**RE: Aggregate Industries-WCR, Inc. Daniels Sand Pit 2, M1973007SG
Response to TR-09 Adequacy Review letter dated November 26, 2019.**

Regarding: Daniels Sand Pit 2, Permit No. M-1973-007-SG
Response to TR-09 Preliminary Adequacy Review

In response to Timothy Cazier's November 26, 2019 Technical Revision (TR-09) Preliminary Adequacy Review, this letter provides responses to DRMS comments. Mr. Cazier's comments pertain to a letter dated October 14, 2019 from Brierley Associates to Aggregate Industries. Since the time of that letter, the key staff from Brierley (Steve Kuehr and Sarah Myers) who prepared the letter are now at Lithos Engineering. Steve and Sarah are hereinafter referred to as the Design Team.

Figure 2.1 Geometry and Material Properties

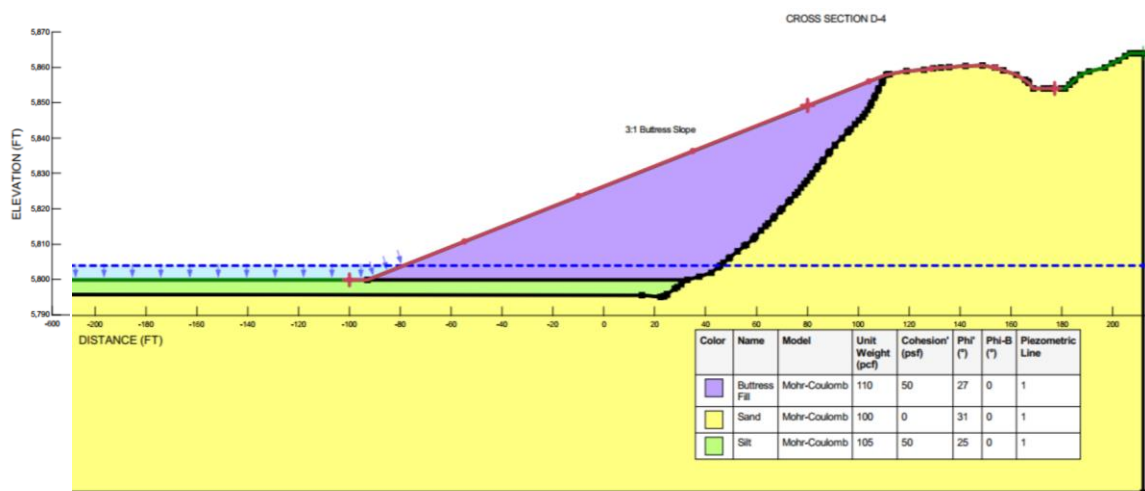
Comment: *Both Cross Sections D-1 [Fountain Mutual Ditch above the Recharge Pond to the south] and D-4 [Fountain Mutual Ditch above the New Wash Pond to the south] have Factors of Safety(FoS) for stability well below that required by the Mined Land Reclamation Board Policy 30. A mitigation plan is required. Please submit a mitigation plan for both these areas demonstrating how the required FoS will be met, including a schedule for the work. Both the mitigation plan and the schedule will require approval by the DRMS.*

The mitigation plan consists of a buttress fill which will be installed to stabilize the steep mine slope which exists beneath the Fountain Mutual Ditch above the new wash fines pond. Buttress fills are a common technique to stabilize slopes. The buttress is intended to flatten the existing mine slope to 3H:1V. In March 2020, the Owner provided additional survey for the area beyond

(south of) the existing toe of slope. This area is currently under water so a bathymetric survey was performed. On-site recycled concrete and stockpiled sand will be used as the fill material. The buttress footprint will extend into the new wash pond which is partially filled with water and wash pond fines. The wash fines consist of submerged, very loose, saturated silt. The buttress material is significantly denser and will displace a portion of the wash fines.

Laboratory testing was performed on selected stockpile samples in order to obtain engineering parameters needed in the analysis. The laboratory results are attached to this letter for reference. A Slope/W analysis was performed for the proposed mitigation plan which resulted in a Factor of Safety (FOS) of 1.8. The design requires that the wash fines be stabilized with recycled crushed concrete. But, for the purpose of the slope stability analysis, the stability contribution of the broken concrete was neglected. The recycled concrete will be crushed to 12-inch minus. Slope geometry and geotechnical parameters used in the analysis are shown in Figure 2.1. Figure 2.2 presents the critical failure surfaces and calculated FOS for the proposed construction. The grading plan, construction sequence and typical cross section for the proposed construction are attached to the end of this letter as Plate 1 and Plate 2.
